# Service Bulletin

Bulletin No.: 24-NA-049

**Subject:** Information on Blazer EV Police Vehicle Air Deflector Installation

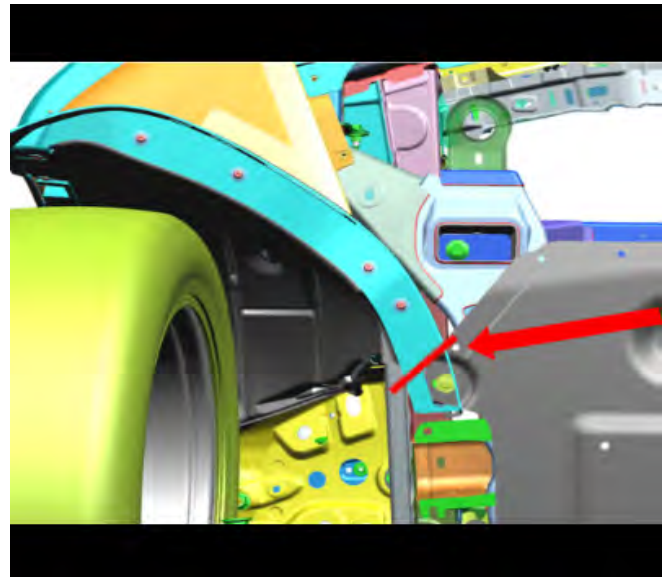
<b>Involved Region or Country</b>	North America
<b>Condition</b>	On Blazer EV POLICE vehicles during PDI the dealer may find that the front air deflectors are too long and interfere with an underbody shield.
<b>Cause</b>	The cause of the condition may be due to the aero panel was added after the air deflectors were developed.
<b>Correction</b>	Trim the air deflectors like illustrated below.

If you encounter a vehicle with the above concern, trim the air deflectors in the locations illustrated below.
